Rezoning Transportation Analysis

Petition Number: 2025-131

Revision Log:

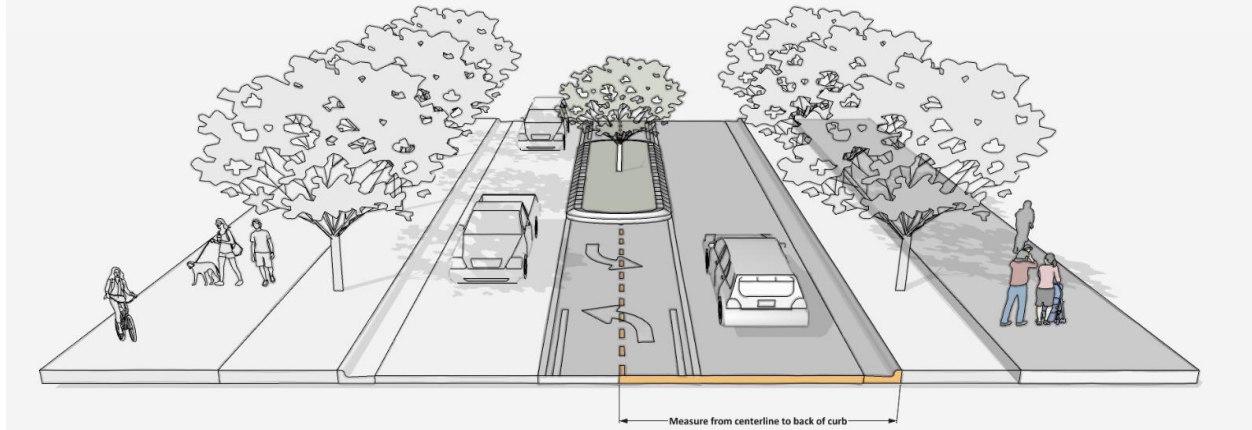
- a. ~~Grier/Rocky River Road: Future back of curb and gutter is to be located 30 feet from road centerline and must be shown in the future location according to UDO Article 32.7 and Charlotte Streets Map.~~

~~Label and dimension the existing and future back of curb and gutter from the centerline for each road on the site plan.~~

~~**CLARIFYING COMMENT 2-19-26:** Revise callout/leader of "EX. CENTERLINE" to show existing striped center dividing line and show 2 westbound through lanes along project frontage.~~

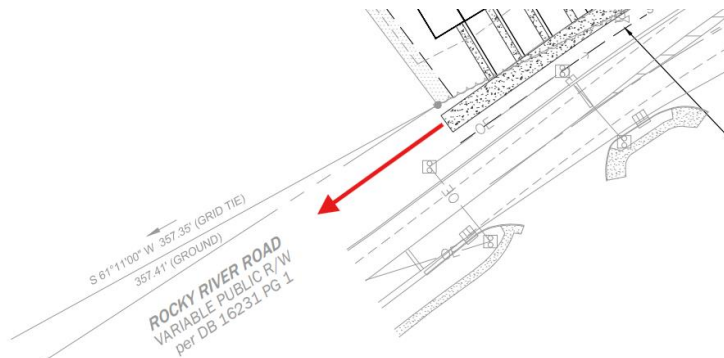
- b. ~~Rocky River Road: Future back of curb and gutter is to be located 19 feet from road centerline and must be shown in the future location according to UDO Article 32.7 and Charlotte Streets Map.~~

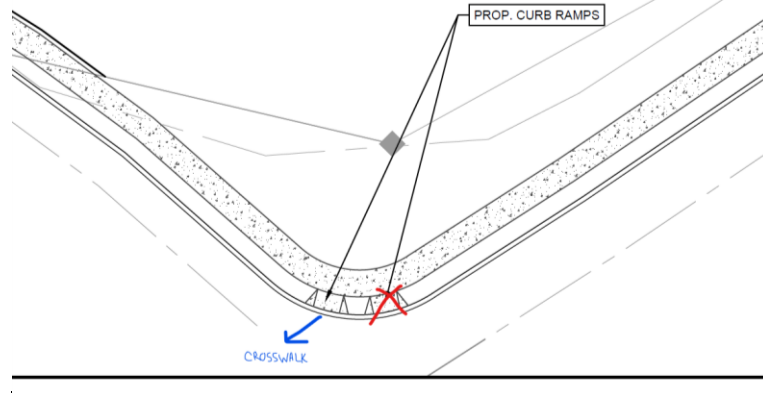
5. ~~**OUTSTANDING CDOT REQUEST FROM 01-22-26:** Revise site plan and conditional note(s) to commit to provide pedestrian facilities by constructing shared use path (SUP) connecting to existing crosswalk at Grier Rd and Rocky River Rd per CDOT request. Install a curb ramp matching the pedestrian paths width. This will complete a pedestrian network and create safe access to associated amenities in the area including Reedy Creek Park across the street.~~

CLARIFYING COMMENT 4-23-26: ~~Revise site plan and conditional note(s) to commit to providing pedestrian connection to the existing crosswalk at Grier Rd / Rocky River Rd. Show one curb ramp and crosswalk connection to existing crosswalk. A pedestrian signal will be required to be installed. Screen in pedestrian refuge and a conditional note committing to finalizing pedestrian accommodations during permitting with CDOT.~~

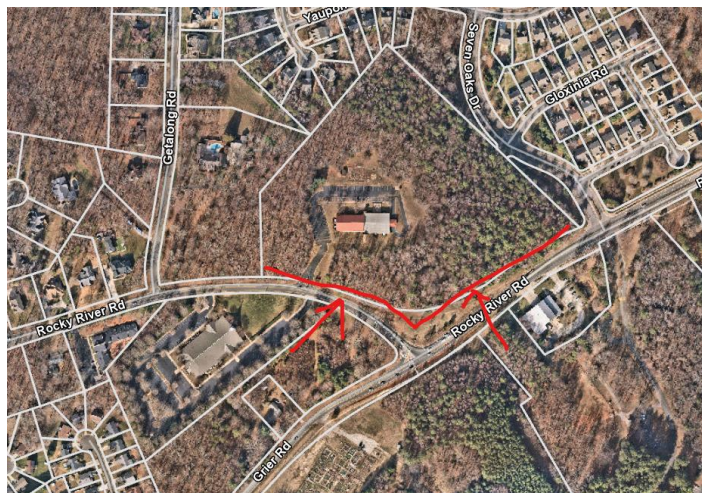
CDOT REQUEST: In association with the required pedestrian signal, it is requested that the petitioner coordinate, where possible, the upgrade of existing pedestrian signals to meet current standards at the intersection. If the petitioner is agreeable to this, please add a conditional note committing to this improvement. Please reach out to Brent.Hyatt@Charlottenc.gov to discuss further.

OUTSTANDING COMMENT FROM 3-26-26: This petition has been reviewed per subdivision requirements, and it was determined that street improvements are required along the entire frontage of the parcel in accordance with UDO Article 32.7. An 8-foot planting strip and a 12-foot Shared use path is required along the entire Grier Road and Rocky River Road frontages, not just the development area. Include ramps at the corner of Grier and Rocky River. Curb and gutter is required to be constructed per Charlotte Streets Map. See comment 1 for curblines locations for both frontages. Show these improvements on the site plan along with callouts and dimensions from the roadway centerline. Add conditional notes to commit to installing these improvements and show on site plan.

CLARIFYING COMMENT 5-27-26: An 8-foot planting strip and a 12-foot Shared use path is required per UDO Article 32.7 and must be provided along the entire Grier Road and Rocky River Road frontages, not just the development area. This was shown in the previous site plan submittal.

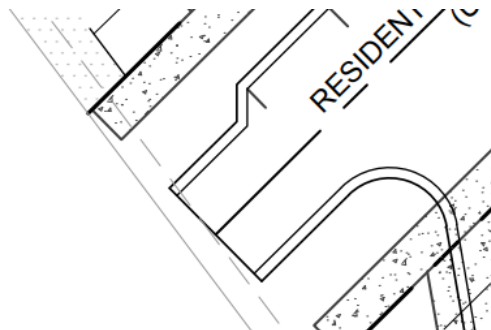
6. ~~OUTSTANDING COMMENT FROM 1-22-26:~~ Revise site plan and conditional note(s) to clearly show/label internal alleys as private. Identify them as either a private street or private alley. Add a conditional note identifying each.

7. Revise site plan and conditional notes to commit to providing internal public road as Local Residential Wide Street with 8' planting strip and 8' sidewalk. Label and dimension the future back of curb and gutter from the centerline of the proposed road.

~~CLARIFYING COMMENT 2-19-26:~~ Label and dimension the future back of curb and gutter from the centerline of the road on the site plan.

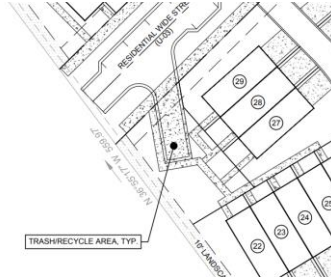
9. ~~OUTSTANDING COMMENT FROM 1-22-26:~~ Revise site plan and conditional note(s) to provide labels and dimensions for driveway spacing and angle of intersection for proposed “trash/recycle area.” The angle of a driveway intersection with the public or network required private street shall be 90 degrees in accordance with UDO Article 31.3.

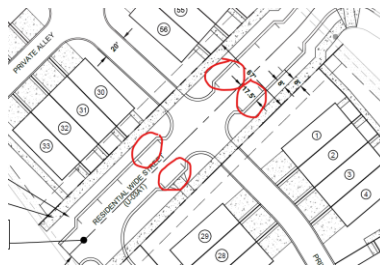
10. ~~OUTSTANDING COMMENT FROM 1-22-26:~~ Revise site plan and conditional note(s) to show that on-street parking must meet City standards, and ADA/PROWAG guidelines. Show proper spacing from driveways and curb ramps etc...One of the on-street parking spaces are to be designed as an ADA stall.

~~CLARIFYING COMMENT 4-23-26:~~ Remove proposed on-street parking spaces to ensure that the minimum required spacing is met per CLDSM.
